# Access Compliance Report

## Public Rights-of-Way

### (Curb Ramps)

Intersection ID: 22391	Main Street: SHARON_RD	Cross Street: WHISTLESTOP_RD	Location: E
ADA ID: 52A0CC0247CE	Ramp Type: PerpDiag	Initial Pass/Fail: Fail	Overall Compliance: No
Severity Score: 8.75			
Codes/Mitigation Info/Possible Solution		Field Measurements/Component Compliance

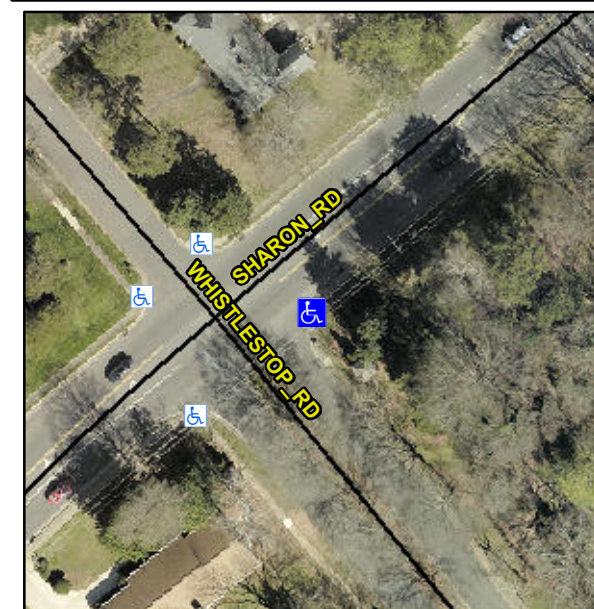
**Not Found, R304.5.1**

Compliance	Description	Data	Compliance	Description	Data
N/A	Ramp Length (in)	63.5	Yes	Ramp Slope (%)	8.1
No	Ramp Width (in)	38.0	Yes	Ramp XSlope (%)	1.4
N/A	Flare Type LT	N/A	N/A	Flare Type RT	N/A
N/A	Flare Slope LT (%)	N/A	N/A	Flare Slope RT (%)	N/A
N/A	Flare Traversable LT?	N/A	N/A	Flare Traversable RT?	N/A
N/A	Landing Length (in)	N/A	N/A	DWS Provided?	N/A
N/A	Landing Width (in)	N/A	N/A	DWS Contrast?	N/A
N/A	Landing Slope (%)	N/A	N/A	DWS Length (in)	N/A
N/A	Landing X Slope (%)	N/A	N/A	DWS Full Width?	N/A
N/A	Landing Curb? (Y/N)	N/A	N/A	DWS Offset (in)	N/A
N/A	Shared Landing?	N/A			
N/A	Gutter Ponding?	N/A	N/A	Gutter Slope (%)	N/A
N/A	Gutter Lip Ht (in)	N/A	N/A	Gutter X Slope (%)	N/A
N/A	Painted X Walk1?	No	N/A	Painted X Walk2?	No
	X Walk 1 Direction	To NW		X Walk 2 Direction	To SW
N/A	X Walk 1 Width (in)	N/A	N/A	X Walk 2 Width (in)	N/A
	X Walk 1 Slope (%)	7.1		X Walk 2 Slope (%)	4.0
	X Walk 1 X Slope (%)	0.6		X Walk 2 X Slope (%)	5.0

**Remove & Replace Curb Ramp With Two New Directional Ramps or Equivalent.**
